IBM 8260 Multiprotocol Intelligent Switching Hub Token Ring Media Modules Release Note

IBM Corporation • IBM Part Number 02L2482 • August 7, 1997

This release note applies to the following IBM 8260 Token Ring Modules Version v1.50:

Setting the Lobe/Trunk Jumper

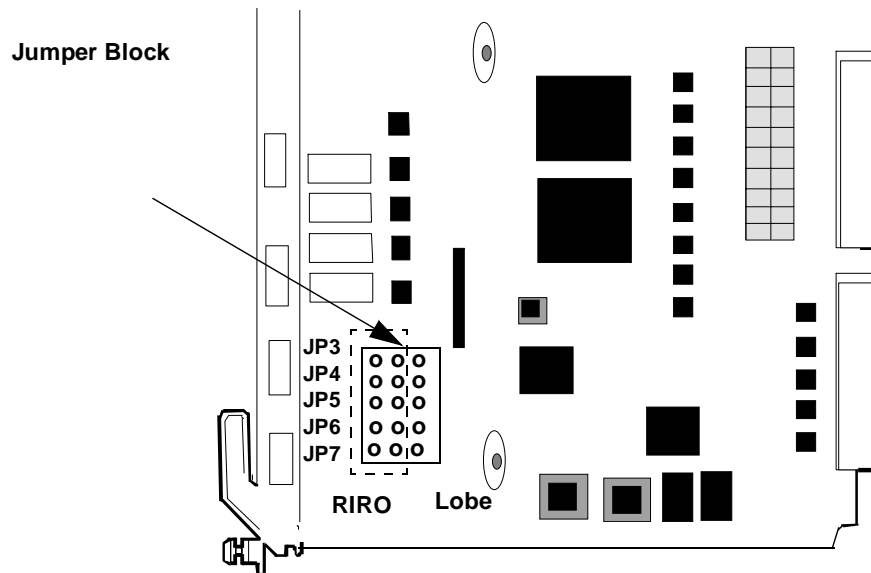
This section applies to Chapter 3, Installing the Module, the section titled Setting the Lobe/Trunk Jumper (T18PSA and T18MSA). In Figure 3-2, the module component side view is missing the JP3 switch on the jumper block.

The following diagram shows the correct jumper for Figure 3-2.
